From: clayton.shedrow[redacted]
Sent: Wednesday, March 05, 2008 4:42 PM
To: Dimarzio, John A.
Cc: clayton.holloway[redacted]; greg.burbage[redacted]; drew.grainger[redacted]; betsy.westover[redacted]; perjetta.hightower[redacted]
Subject: Fw: Data Call Status

Subject Re: Fw: Data Call StatusLink

In addition, two questions came up today related to the Immobilization Data Call Response table.

SKETCH NUMBER: SK-DE-SAB-0006

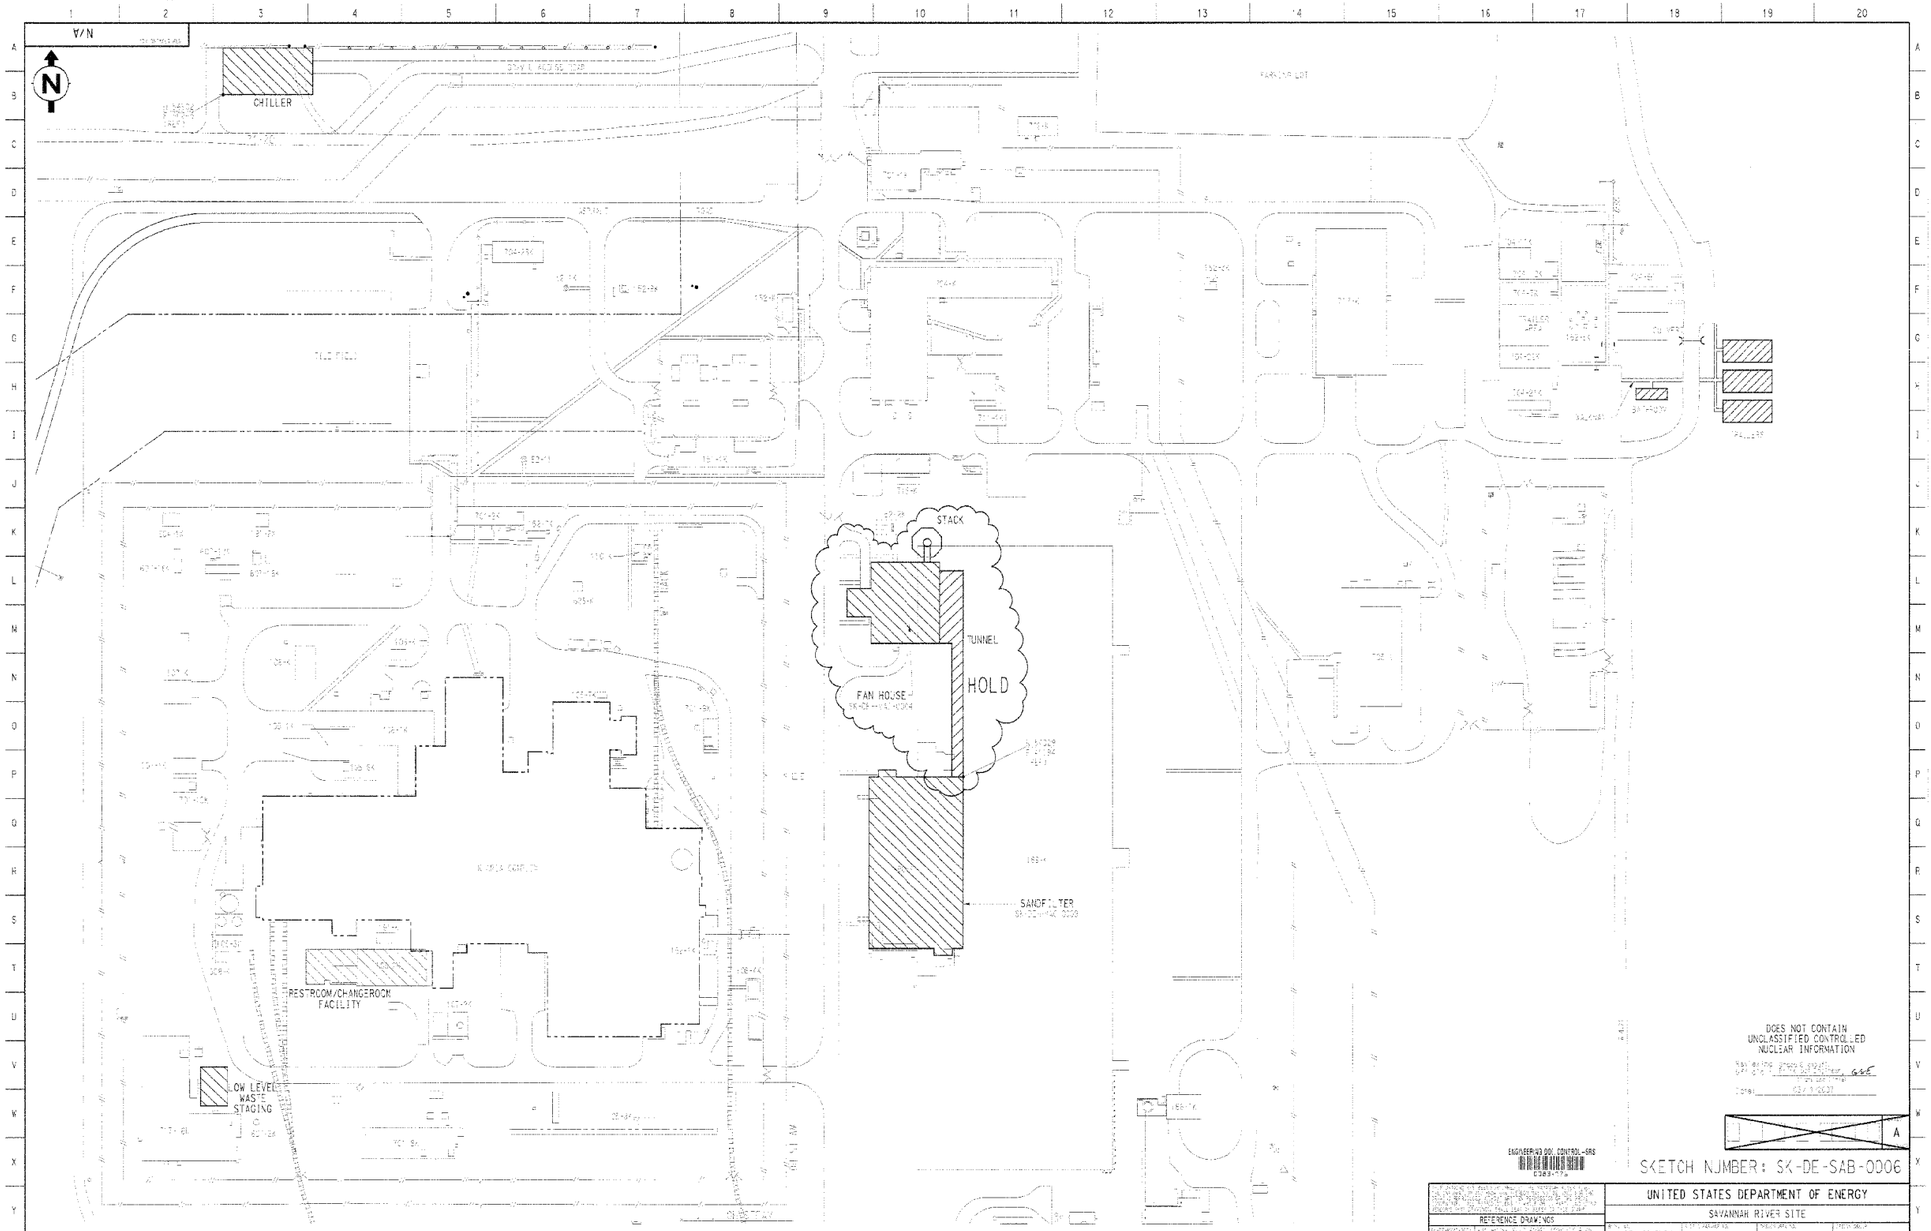
- Page 1, column 1, Plot Plan. Can you supply a plot plan that shows the areas to be disturbed in K-Area? Site Layout SK-DE-SAB-0006?
- Page 1, column 2, area disturbed = 385,010 sq ft. This appears to conflict with file "csowk00012-sitework" that indicates 84,340 sq feet (~2 acres) would be disturbed.

Attached is a copy of the Site Layout SK-DE-SAB-0006. The first number we gave them on 10/27/07 - 84,340 sq ft ~ 2 acres is the correct number for the area being disturbed as indicated in the referenced scope of work (C-SOW-K-00012). I don't know where the new number came from but it is definitely too high.
